ILLINOIS POWER COMPANY

September 28, 1984

Subject: Clinton Power Station Unit 1  
DRAFT Technical Specifications

Illinois Power is enclosing a revised mark-up of the Clinton Power Station "DRAFT" Technical Specifications for your review. The changes indicated in the enclosure are provided as a result of our review of plant specific design information, information contained in the Clinton Power Station Final Safety Analysis Report, requirements/commitments delineated in the Clinton Power Station Safety Evaluation Report (NUREG-0853) through Supplement No. 3, and the Technical Specifications of recent licensees.

FIGURE 4.7.4-1  
 SAMPLE PLAN 2) FOR SNUBBER FUNCTIONAL TEST

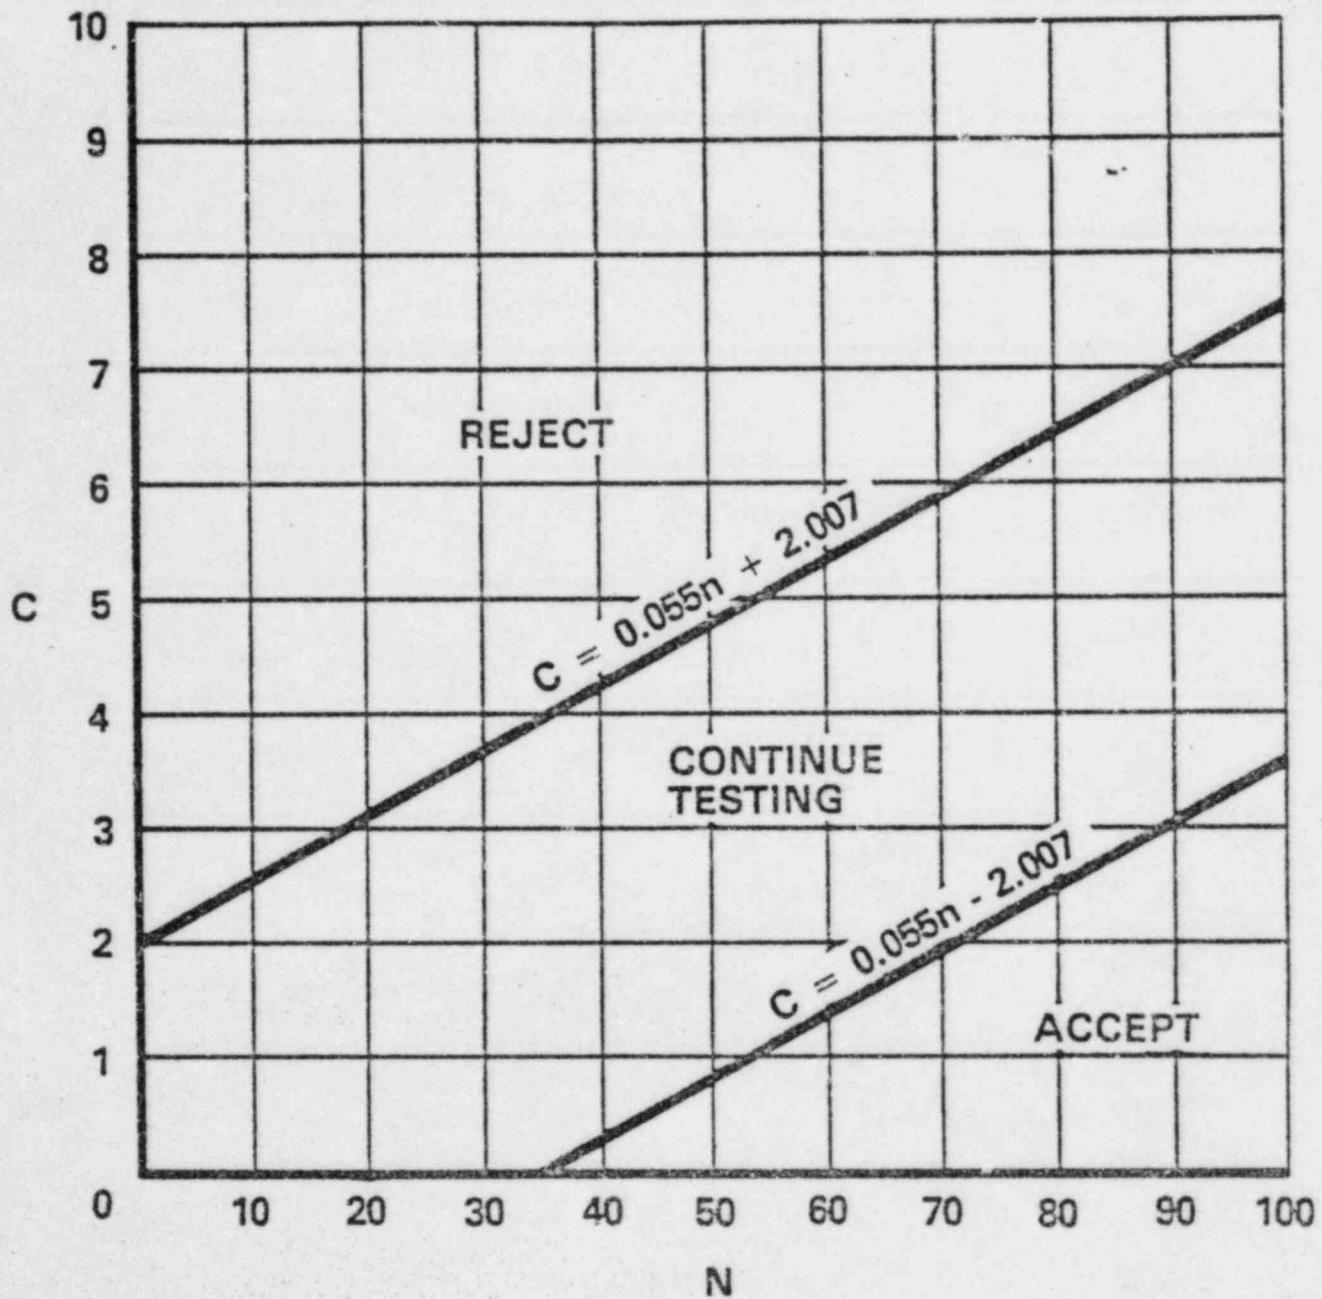
Delete this page  
 Insert Figure 4.7.4-1  
 after this page  
 / CMS

Bases Figure B 3/4.4.6-1

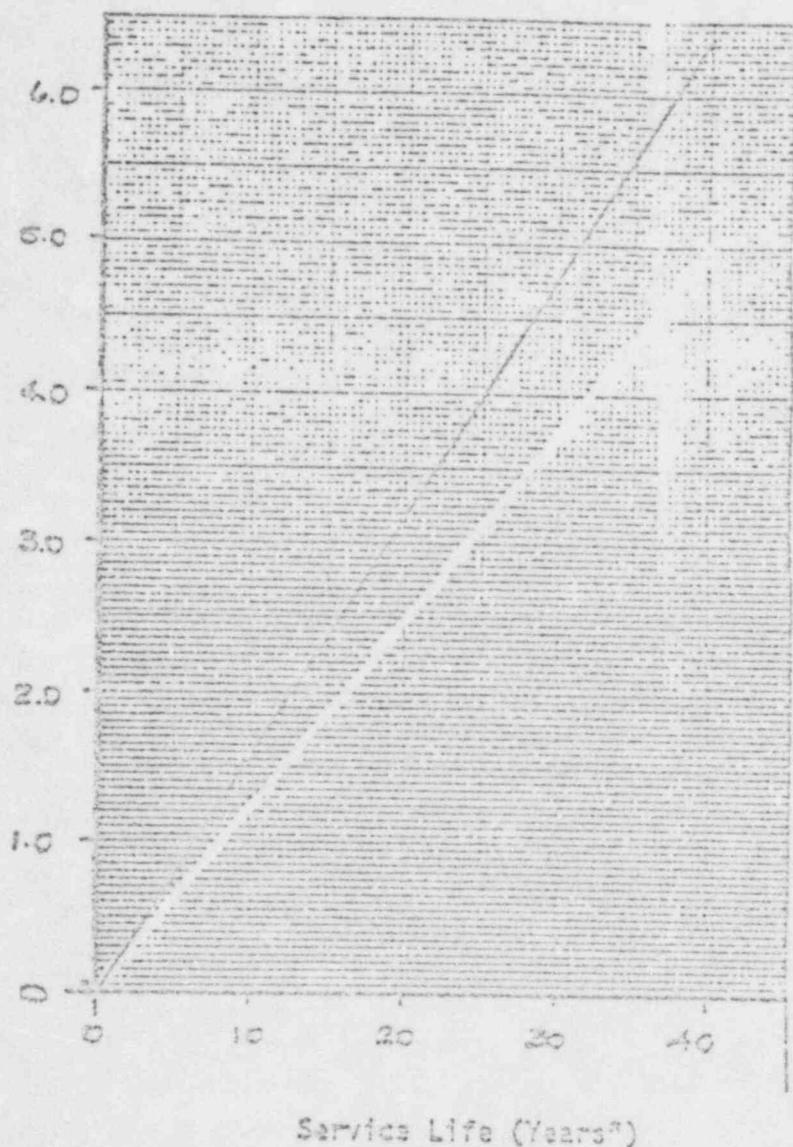
*Add Attached Figure*

FIGURE 5.1.2-1

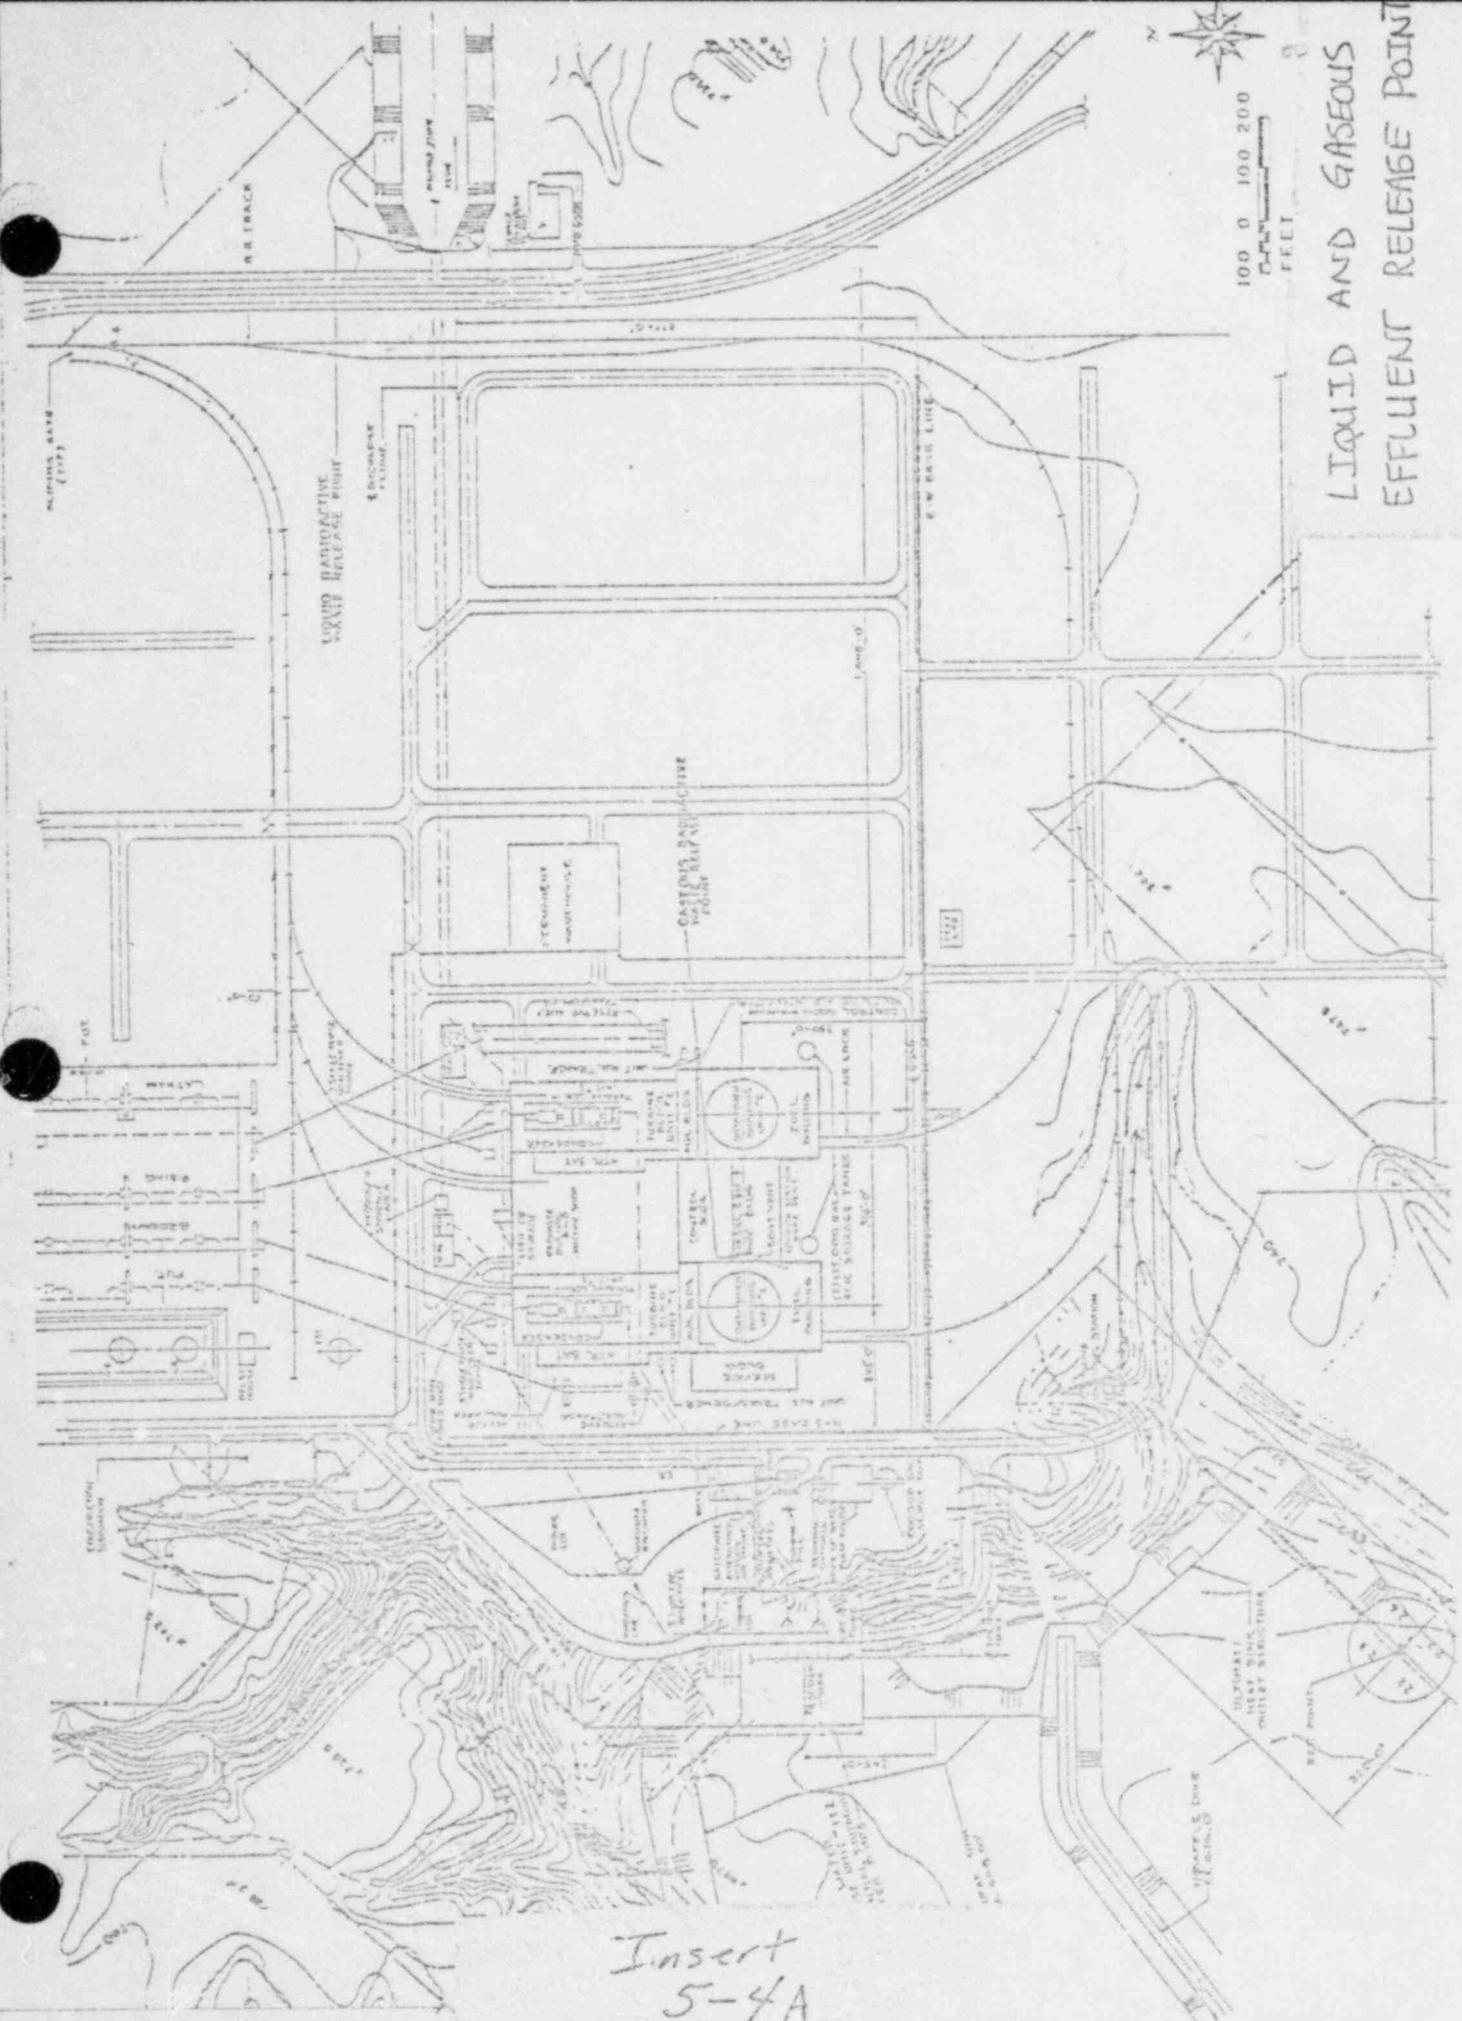
Replace with attached /CB  
figure
